EPA Superfund
Record of Decision:

VIENNA TETRACHLOROETHENE
EPA ID: WVD988798401
OU 01
VIENNA, WV
09/27/2002

Record of Decision

**Vienna PCE Superfund Site
Vienna, West Virginia**

Figure 3
Round 1 Concentrations of PCE
in Shallow Groundwater Samples
February 2001

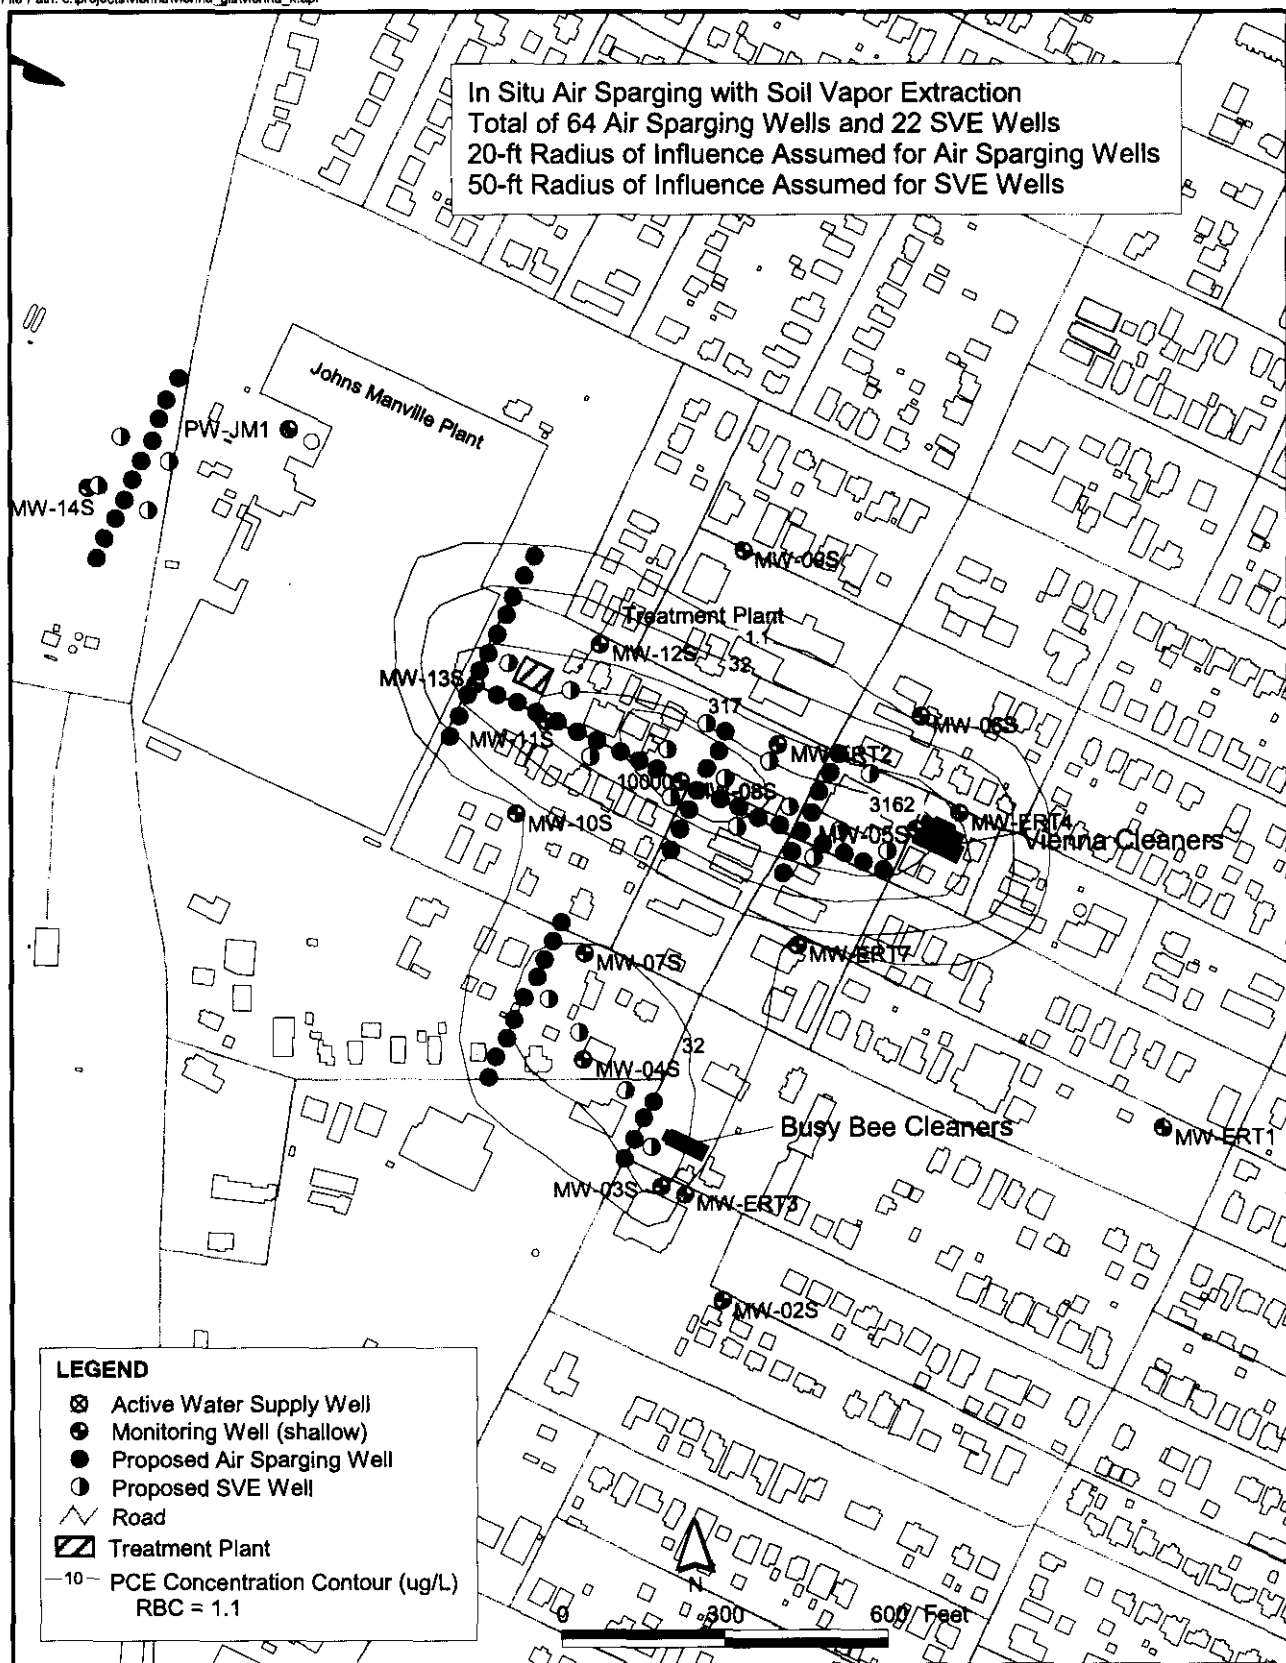
- B.17 A citizen wrote: Figure 3 of the Appendix (PCE concentrations, February 2001) shows reasonable coverage by monitoring wells to produce the concentration contours that are inferred, except for the lower concentration contours connecting the smaller Busy Bee Cleaners source across-gradient to the main body of the Vienna Cleaners plume. Such a connection would seem to require data from another monitoring well, and would also require contaminant movement along, rather than perpendicular to, the potentiometric contours shown on Figure 4.

- B.18 A citizen wrote: The significant message of Figure 3, however, is that the highest concentrations of PCE have only moved about three blocks down 29th street in the 50+ years since the Vienna Cleaners began operating in the late 1940's. It would appear that the PCE plume would likely not emerge on the west side of the Manville Plant for decades more. Given the additional facts that waste PCE dumping has not occurred for decades, and a "gap" of much cleaner groundwater now exists back upgradient toward the source, a relatively lower-level threat is presented and a correspondingly lower-level remedy (than the current Proposed Remedy) is indicated.

- B.20 A citizen wrote: PCE is known to be subject to degradation in groundwater, with EDC and TCE at relatively low levels being typically produced and then degrading. The contouring of the PCE plume (Figure 3) and the relatively clean "gap" back toward the source, where apparently large amounts of PCE are still being recovered from the soil, may imply that

EPA Response: EPA agrees, as depicted on Figure 3, the plume from the Busy Bee cleaners location does appear to have a more northerly component of flow than the plume

EPA Response: EPA agrees that the plume is migrating at a relatively slow rate of speed. However, the contamination has already migrated approximately 1,500 ft, and has seriously threatened the City of Vienna's water supply. (Six municipal wells have already been taken out of service.). Further, there are a number of influences on the plume in its current location that are not present at the Vienna Cleaners area that will accelerate its movement, namely the City of Vienna groundwater production wells. Groundwater modeling studies undertaken by EPA and the USGS indicate that the groundwater plume will accelerate as it draws closer to the City of Vienna production wells. Thus EPA does not believe we should employ a "lower level" remedy to address this problem.

EPA Response: EPA completed a full sampling round of analysis of BOD, COD, DOC and other Natural Attenuation Parameters as detailed in the Remedial Investigation. As a result of this portion of the investigation, EPA concluded that biodegradation of chlorinated hydrocarbons, specifically PCE, in groundwater through reductive dechlorination is not occurring at the Site. However the Selected Remedy will do just as you suggest, as it will supply oxygen via air sparging directly in the center of the plume.
